ANM16Input paper

Agenda item 8.1

## Modification to Guide Line 1033 – the Provision of AtoN for different Classes of Vessels, including High Speed Craft (HSC)

Fig.1 Observer Line of Sight in relation to Specific Background Lighting (BL)

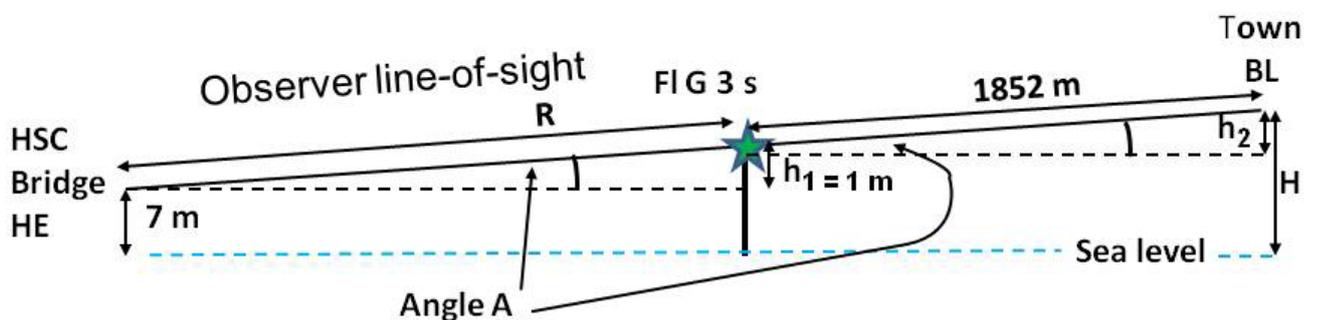
- 2) Background lighting – specific interference from street lights or well-lit buildings, behind an AtoN along an HSC Bridge to AtoN line-of-sight may seriously inhibit the conspicuity of an AtoN of major navigational significance where the latter is most needed; in such cases, it may be necessary to consider the elevation of the AtoN, so that the worst of the interference is above or below the line-of-sight at that location;”

The draft diagram, below - perhaps with a more appropriate flash character (FI (3) G, for example) - may be of use as an illustration of 4.1 d) 2):

$H$  (elevation of specific source of background lighting interference) = 7 m (HSC Bridge Height of Eye) +  $h_1$  (elevation increment of AtoN of major navigational significance above Bridge Height of Eye) +  $h_2$  (elevation increment of specific source of background lighting interference above AtoN of major navigational significance)
